Arboricultural Assessment

Southern Cross Hospital, Newtown

Local Landscape Architecture Collective

Report Prepared
03 September 2018

project number: 1802-978
 drawing number: LA101
 revision: F-25.04.18

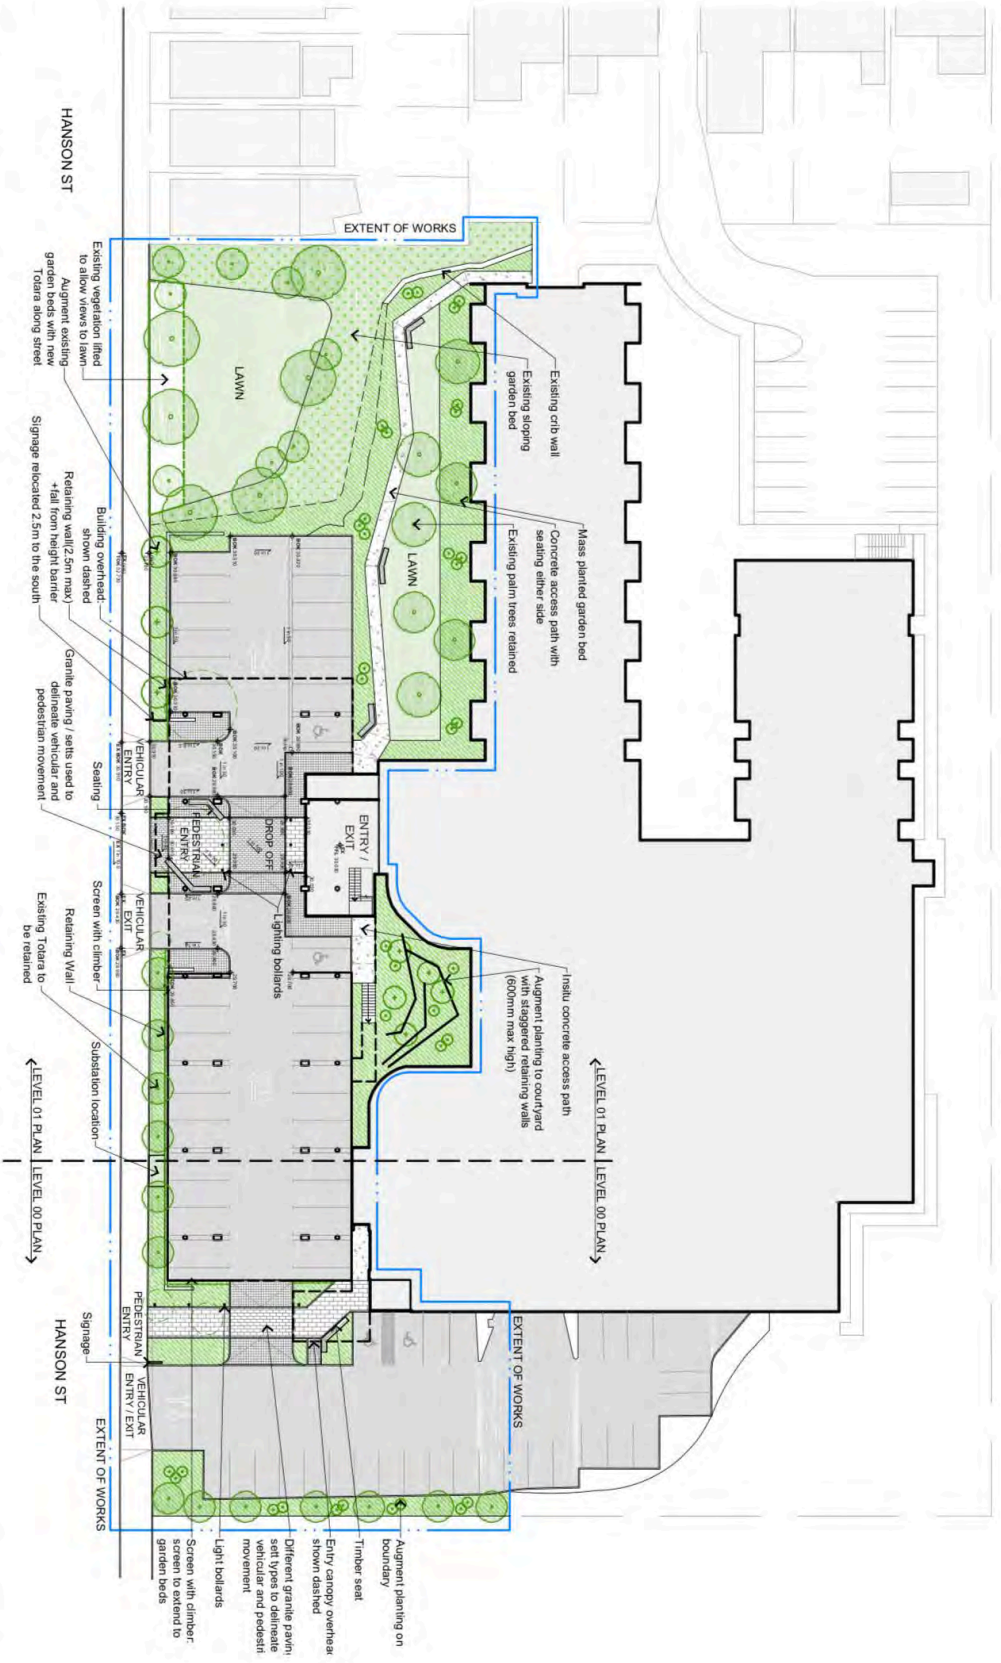
The location of a substation in the eastern garden bed is likely to impact on the adjacent two *Podocarpus totara* (Totara). For installation to take place it is likely trenches will need to be dug and underground services laid.

The plans supplied don't provide measurements and exact locations for the substation so an exact root zone incursion cannot be calculated.

In the first instance, re-location of the substation away from the critical root zones of the trees being retained is preferable.

The plan outlines the removal of 3 of the existing *Podocarpus totara* (Totara). The removal of these trees and stump removal may impact on the adjacent trees being retained. Particularly the removal of the stumps. Care must be taken that no roots are damaged during this process and it is recommended to have these works performed by suitably qualified arborists.

If the substation is to be installed in the location on the site plan stringent tree protection must be implemented and a Arboricultural Impact Assessment report compiled alongside detailed service plans and substation measurements. This will then need to be signed off by the governing authority.

- Appoint a site arborist to oversee the works within the garden beds
- Re-locate the substation or provide detailed plans of its location and measurements in consultation with an arborist
- Implement tree protection plan
